Proposal #34: 9835-06-70, WISC 2026203
C Antigo, 10th Avenue
Western Avenue to Clermont Street
Loc Str
Oneida County

This is Addendum No. 01, which provides for the following:

ADDENDUM NO. 01

Addendum No. 01
ID 9835-06-70
Added Sheet 5A
January 30, 2026

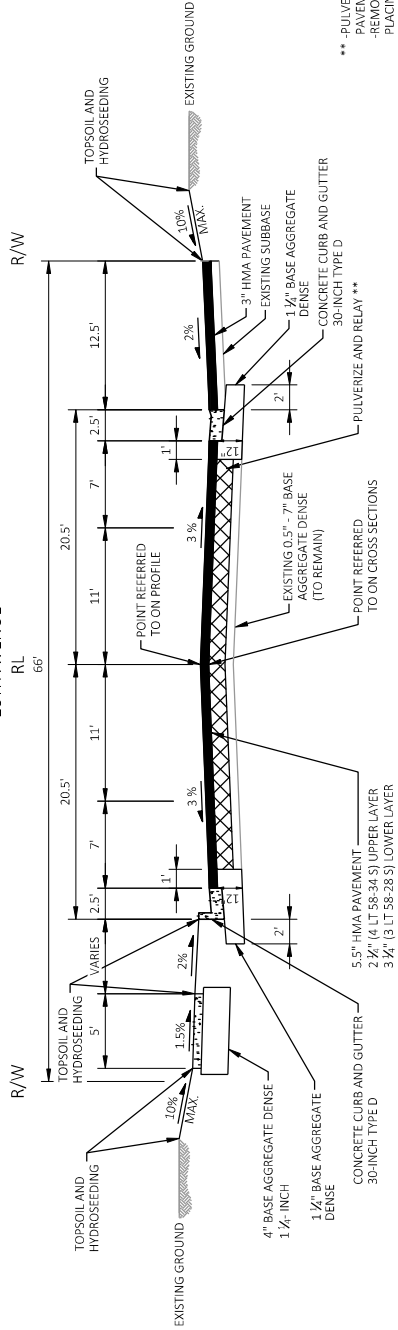
Added Plan Sheets	
Plan Sheet	Plan Sheet Title (brief description of why sheet was added)
5A	Typical Section (addition of side street existing typical section)
10A	Typical Section (addition of side street finished typical section)
163A	Plan and Profile (addition of side street profiles)
257A-D	Side Street Cross Sections (Deleglise Street, Weix Street, Wausau Road, and Gowan Road)

Addendum No. 01
ID 9835-06-70
Revised Sheet 10
January 30, 2026

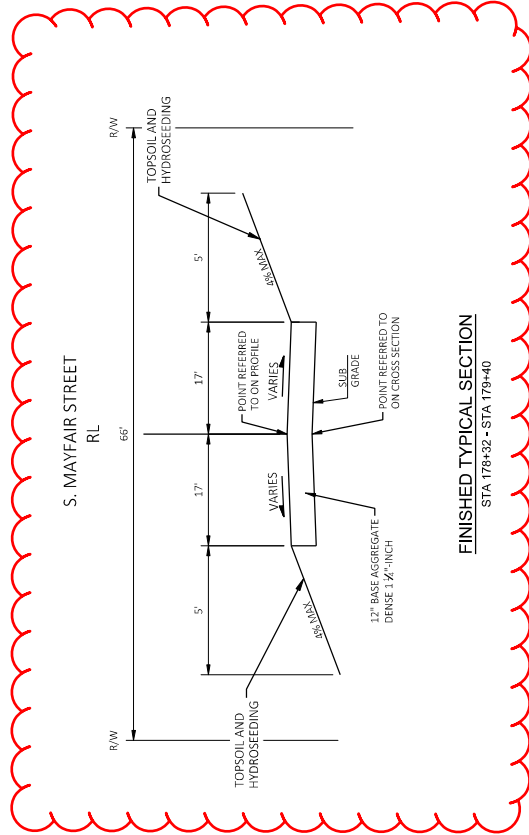
Revised Plan Sheets	
Plan Sheet	Plan Sheet Title (brief description of changes to sheet)
10	Typical Section (Update to S. Mayfair Street finished typical section).
132	Miscellaneous Quantities (Revision in Hauling and Disposal of Contaminated Soil and Management of Groundwater naming and item numbering)
